| <b>B1000<br/>AMP PCB</b>     |                    |  |                    |
| REVISED BY:<br>ERIC PETERSEN | DATE:<br>26NOV2013 | <b>AMP UPDATED TO SAME LEVEL AS 30-45500K-L</b>                                  |                    |

| <b>B1000<br/>Control Panel</b> |             |  |           |

Rev.B: Remove input clip LED: D2, Q4, R524.  
updated amp from 45500K/L.

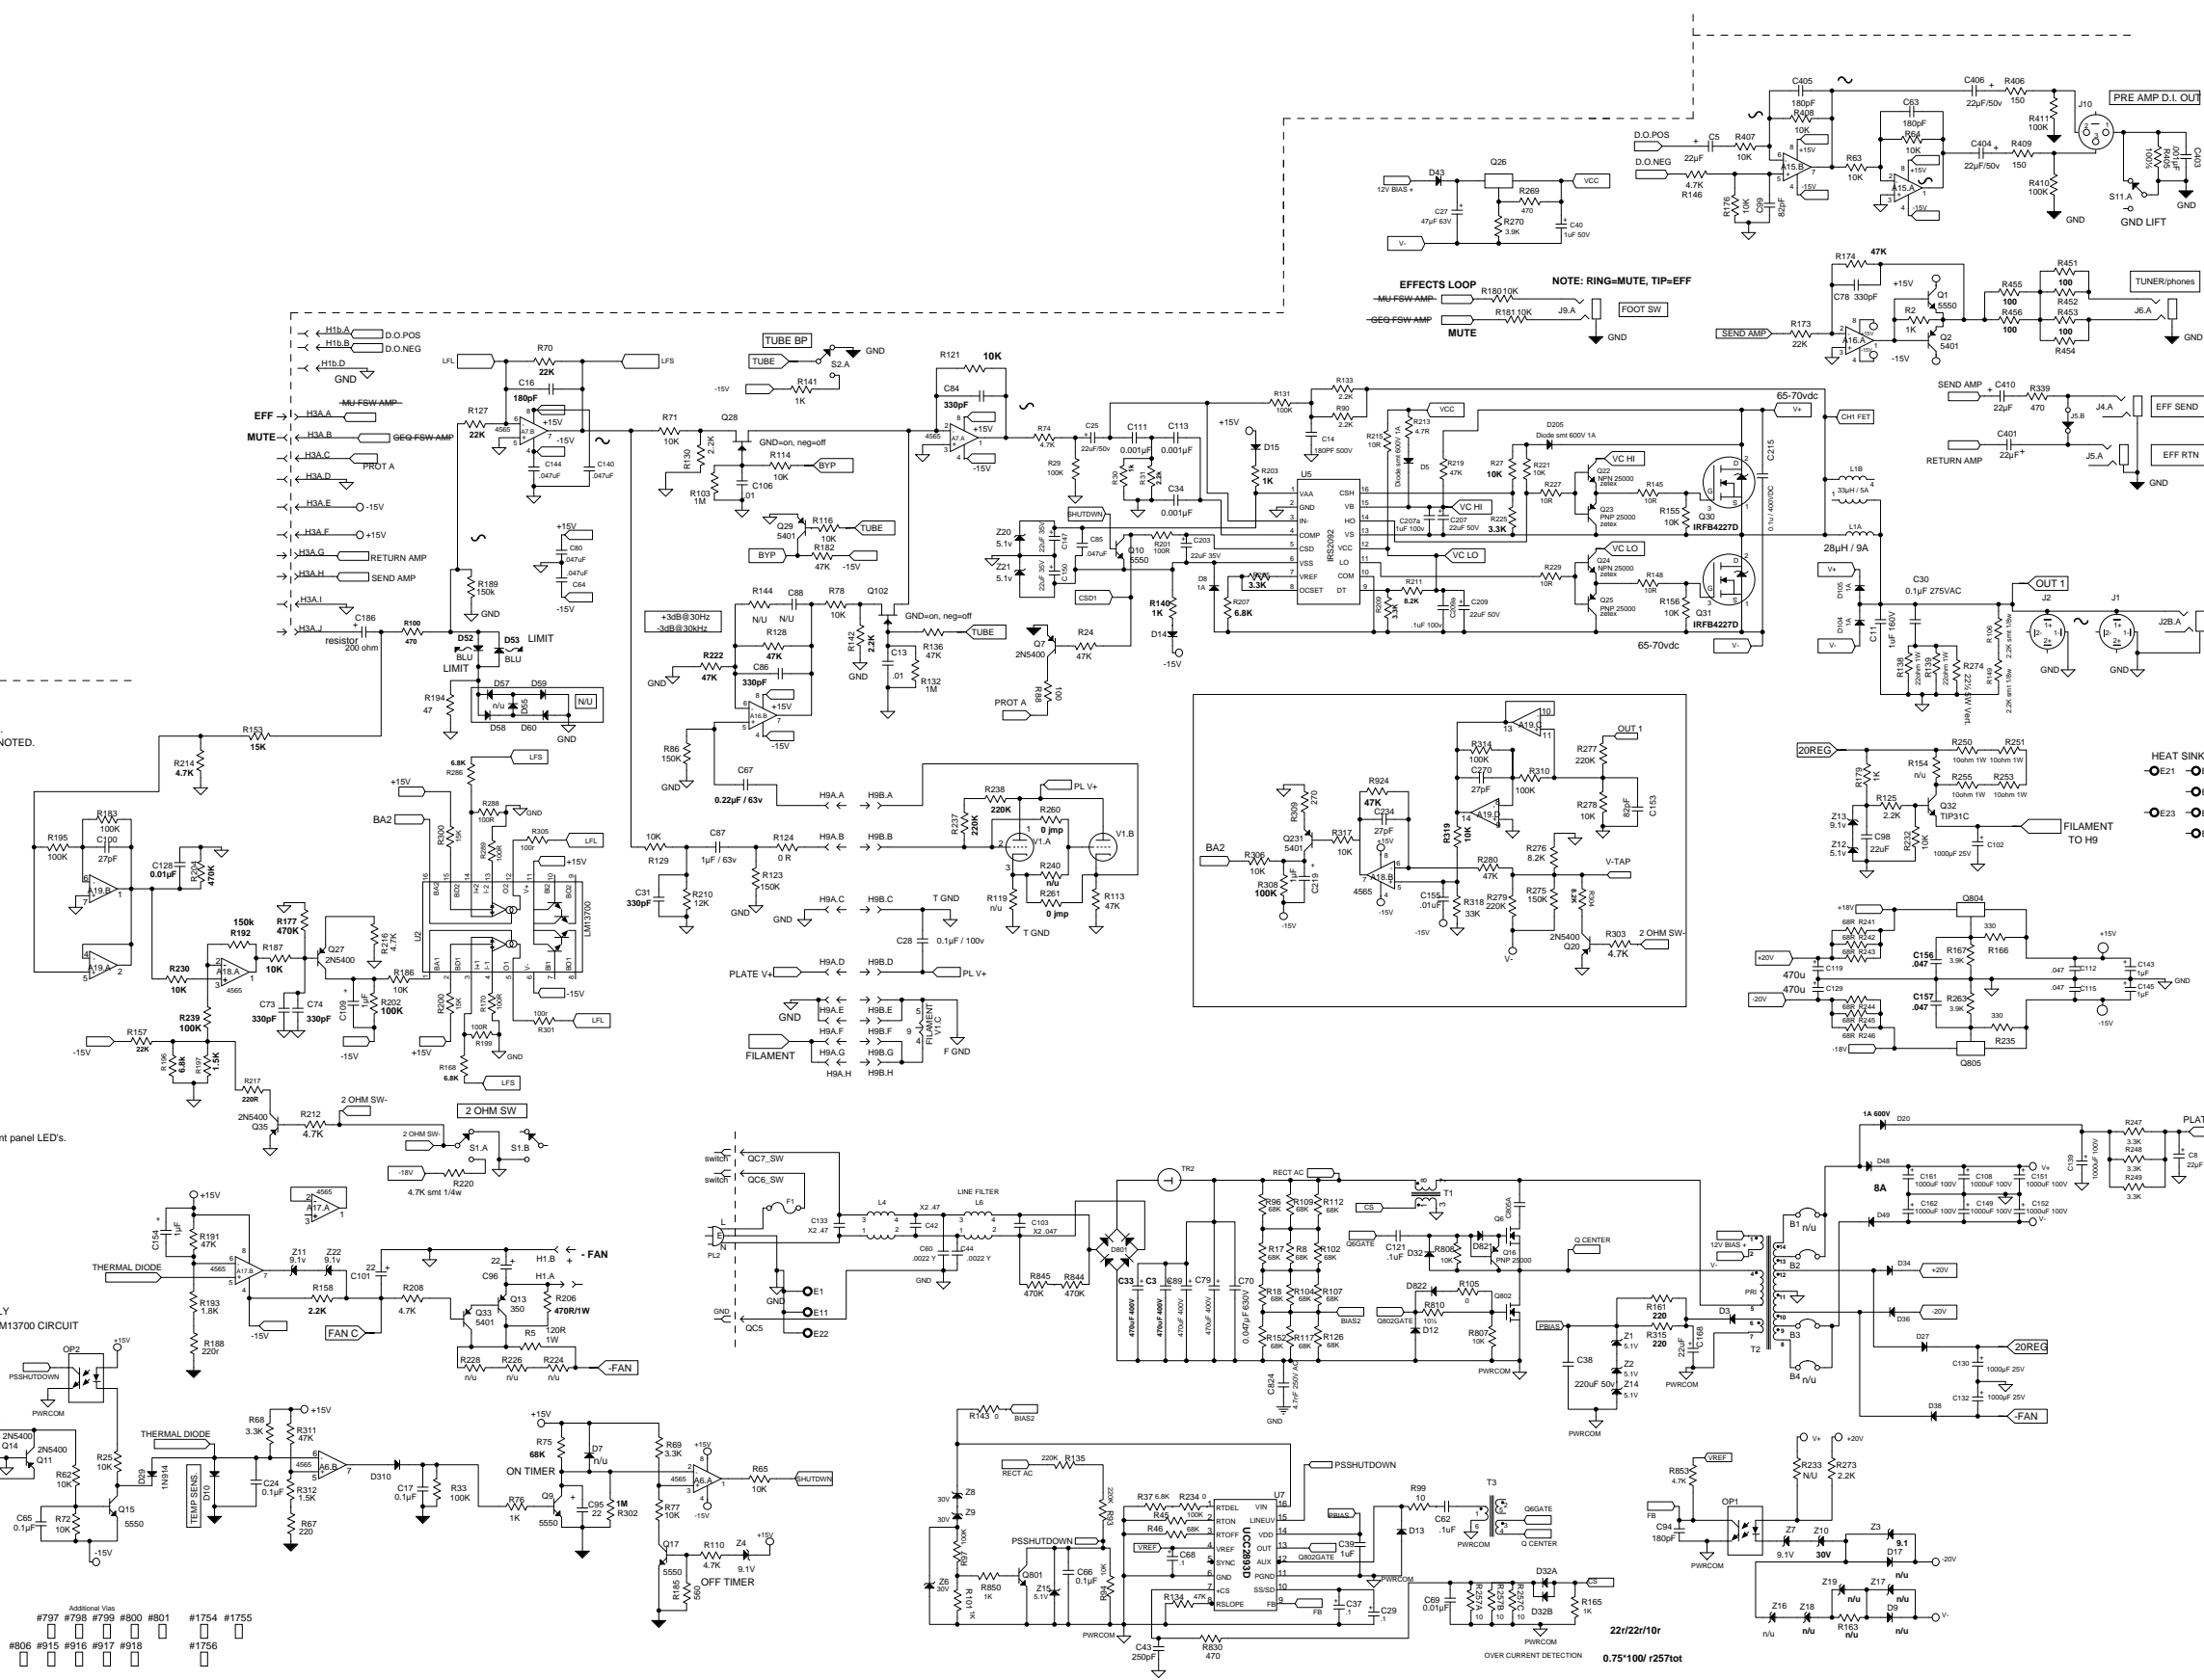
- CHANGES TO REV(K):  
 1. New turn off circuit, and fan start up cap.
- CHANGES TO REV(J):  
 1. Flyback supply corrections and added feedback limiter and front panel LEDs.
- CHANGES TO REV(I) no production:  
 1. Flyback supply
- CHANGES TO REV(H):  
 1. Flyback supply
- CHANGES TO REV(G):  
 1. ADDED C65  
 2. CORRECT DRILL DRAWING FOR PROPER T.H. PLATING
- CHANGES TO REV(F):  
 1. CHANGE TO DISCRETE NON-REGULATED POWER SUPPLY  
 2. FRONT END COMPRESSOR CHANGED FROM OPTO TO LM13700 CIRCUIT  
 3. REMOVED OUTPUT RELAY
